**GM SERVICE AND PARTS OPERATIONS  
DCS1682  
URGENT DISTRIBUTE IMMEDIATELY**

Subject: 06030 Product Safety Recall  
Brake Lamps Inoperative or Continuous Illumination

Models: 2004-2006 Chevrolet Colorado  
2004-2006 GMC Canyon

## PRODUCT SAFETY RECALL

1812077

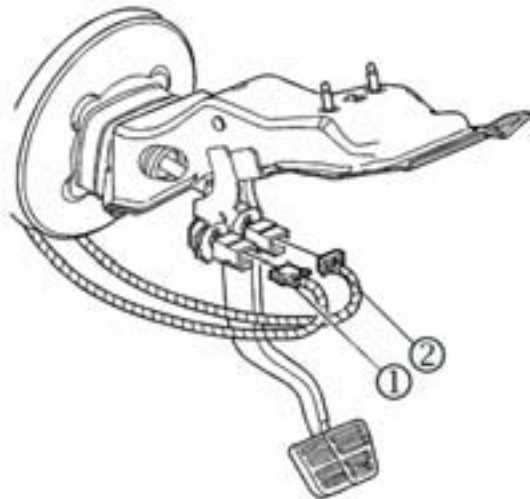
**Important:** There are two switches above the brake pedal - the cruise control switch (1) and the stop lamp switch (2). The cruise control switch is in the outboard position and the stop lamp switch is in the inboard position.

1. Disconnect the cruise control switch connector (1) and stop lamp switch electrical connector (2).
2. Rotate the stop lamp switch (2) counterclockwise.
3. Remove the stop lamp switch (2) from the bracket.
4. Remove the stop lamp switch (2) from the vehicle. Discard the stop lamp switch (2).
5. Inspect the stop lamp switch retainer.
  - o If the stop lamp switch retainer is not broken, proceed to Step 6.
  - o If the stop lamp switch retainer is broken, replace the retainer and then proceed to Step 6.
6. Position the new stop lamp switch near the bracket.

7. Ensure that the switch key-way is properly indexed to the plastic retainer.
8. Install and adjust the stop lamp switch.
  - 8.1 Rotate the switch counterclockwise, allowing the retainer to release.
  - 8.2 Pull the brake pedal rearward to full stop.

**Important:** Do not move the brake pedal during switch adjustment as this will cause an over-adjusted switch which could cause brake drag.

- 8.3 While holding the brake pedal FIRMLY in position rearward, push the switch inward fully until the switch body contacts the brake pedal arm striker plate. At this point the plunger in the switch should be pushed in.
- 8.4 Rotate the switch clockwise until a "click" is heard.
- 8.5 The switch is properly adjusted when there is 7 mm (0.028 in) clearance between the end of the switch barrel and the striker plate on the brake pedal arm.

9. Connect the cruise control switch (1) and stop lamp switch (2) electrical connectors.
10. Check the stop lamp switch for proper operation.
